WHITE LAKE TOWNSHIP
ZONING BOARD OF APPEALS

Address: 10400 Cedar Island Road, White Lake, Michigan 48386

Request Summary: Substandard Lot Review to permit reconstruction of the existing garage and construction of an attached residential addition with an approximately 6-foot west side-yard setback, where an 8-foot setback is otherwise permitted for the substandard lot.

Meeting Date: September 24, 2026

NEW GARAGE & TOPOGRAPHICAL SURVEY

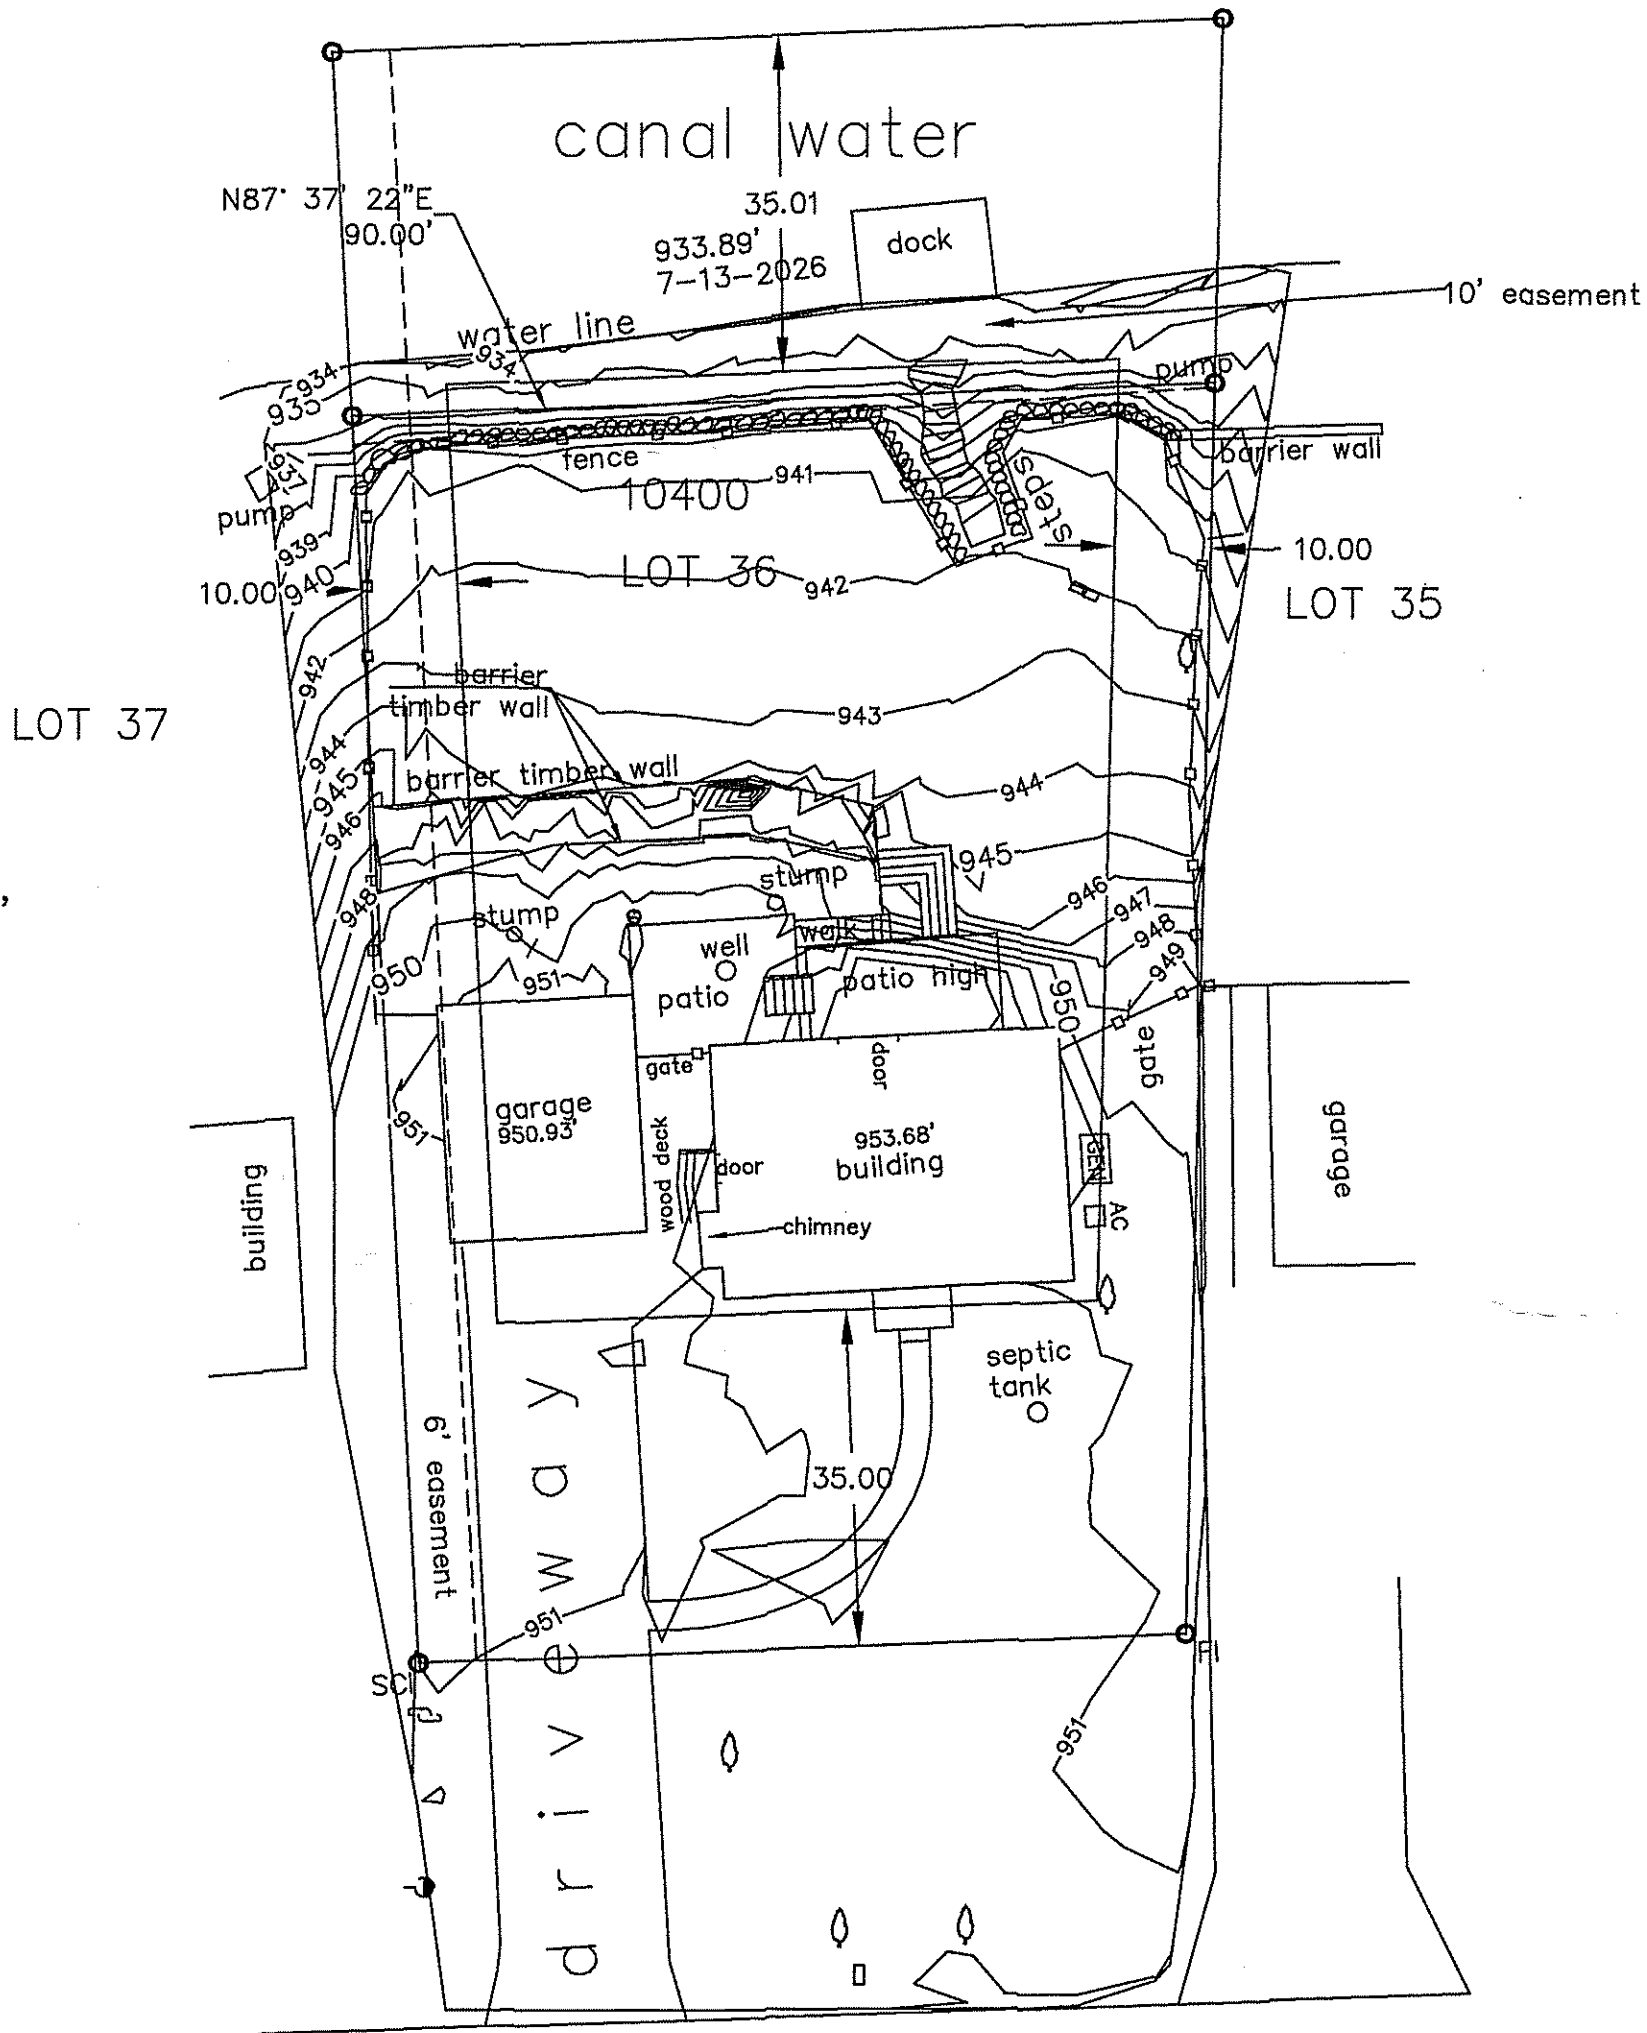
1. Construction shall be substantially consistent with the submitted site plan and survey and shall be limited to the proposed reconstructed garage and attached residential addition.
2. The reconstructed garage and attached addition shall maintain the approximately 6-foot west side-yard setback shown on the approved plans and shall not be located closer to the west property line without further Zoning Board of Appeals approval
3. Roof overhangs, gutters, mechanical equipment, and other projections shall comply with all applicable setback and building requirements.
4. The applicant shall obtain all required Township permits. This approval applies only to the proposed garage reconstruction and attached addition shown on the approved plans and does not constitute approval of any other unpermitted improvement or deviation from the approved site layout.

NEW ADDITION & SITE PLAN

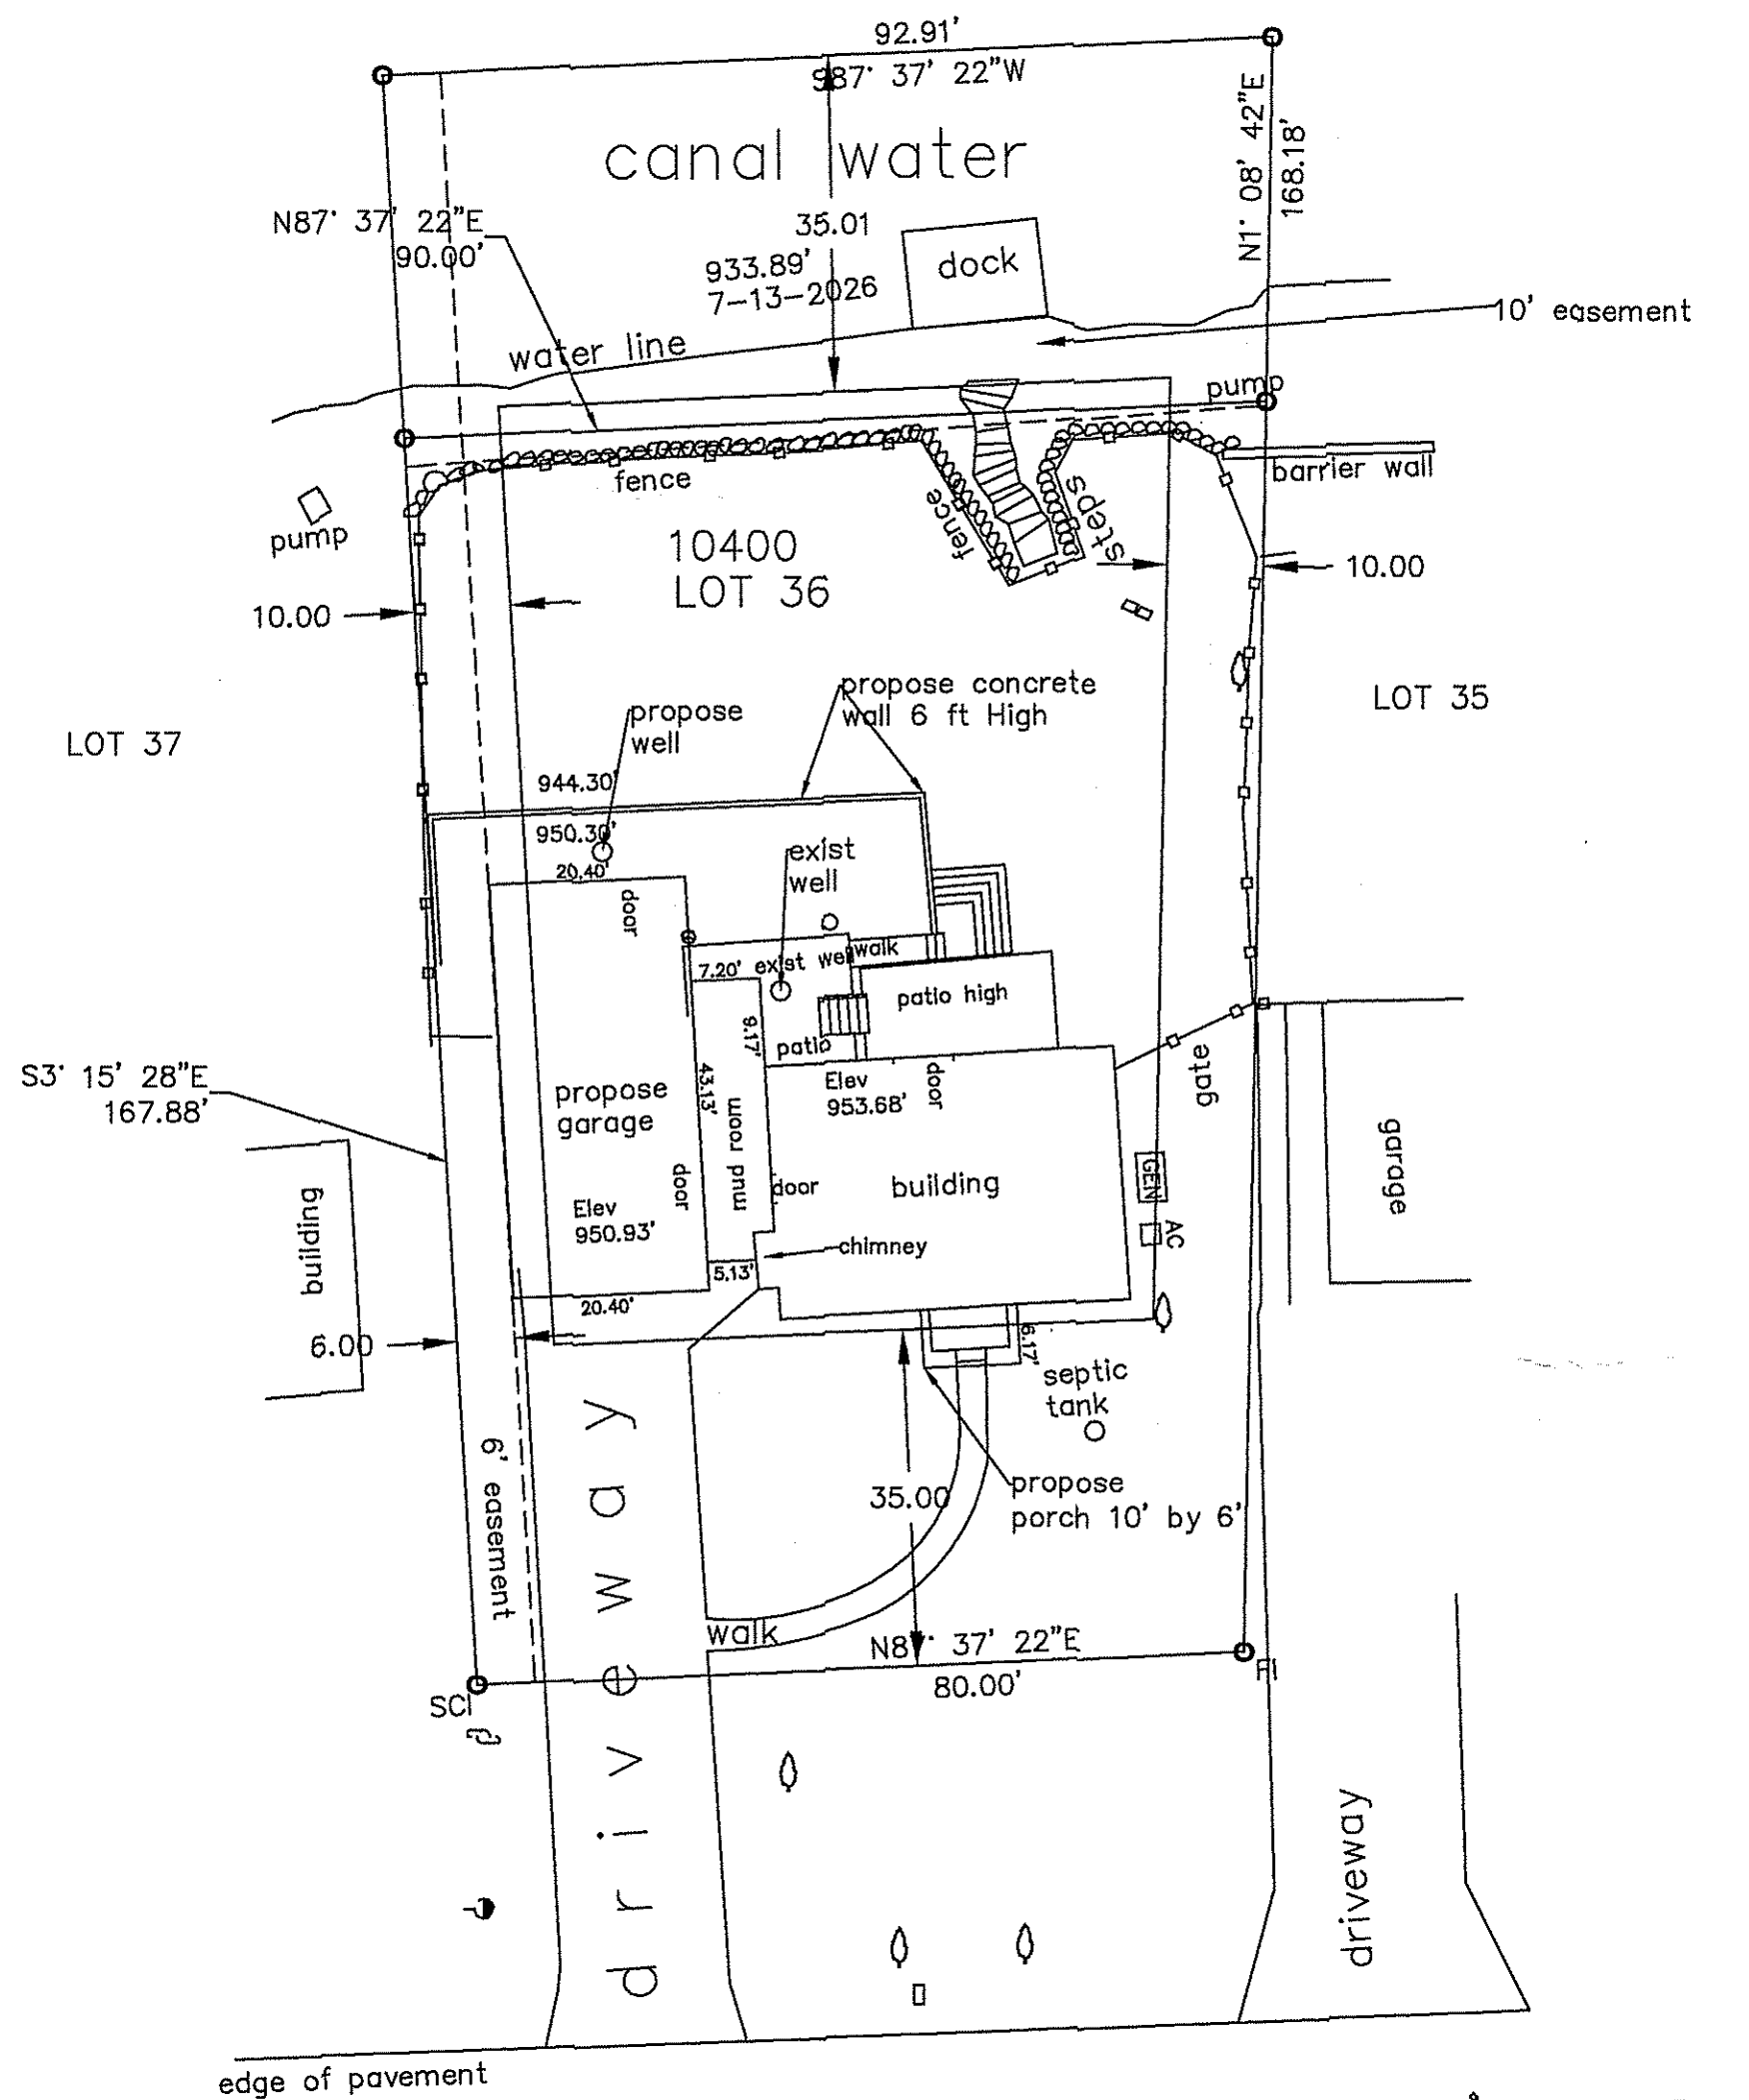
The submitted site plan maintains approximately six feet between the proposed construction and the west property line, which remains greater than the five-foot minimum established for emergency access and fire separation. Vehicular access from Cedar Island Road would remain available.

The submitted site plan depicts the proposed reconstructed garage and attached addition approximately **six feet from the west side property line**. The proposal therefore remains above the absolute five-foot minimum side-yard setback required by Section 7.27(B)(vii). The Board does not have authority to reduce this setback below five feet.

Staff Finding: This standard is met, subject to verification and continued maintenance of a minimum five-foot side-yard setback.
